D0902001 CP, COC CONTAINER, ADVANCED LIGO, PART PDM REV: X-030, DRAWING PDM REV: X-024

ADVANCED LIGO CP COC CONTAINER ASSEMBLY

D0902120 FM, COC CONTAINER, ADVANCED LIGO, PART PDM REV: X-509, DRAWING PDM REV: X-010

TITLE: ADVANCED LIGO FM COC CONTAINER ASSEMBLY

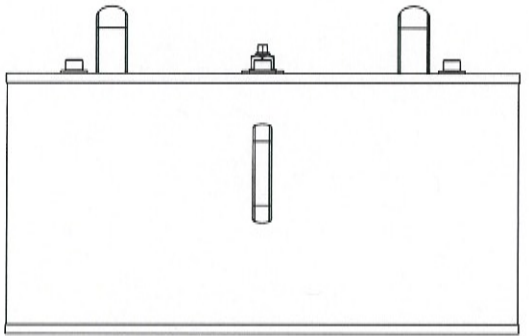
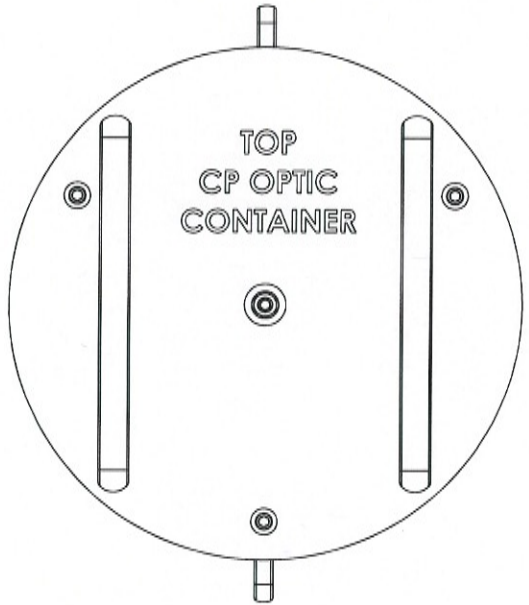
D0902520-4 →
 ADD FOR TOP: →
 D1000958 ADAPTER QTY 1
 D1001025 SHIPPING SLEEVE QTY 3
 92200A150 SHCS QTY 4
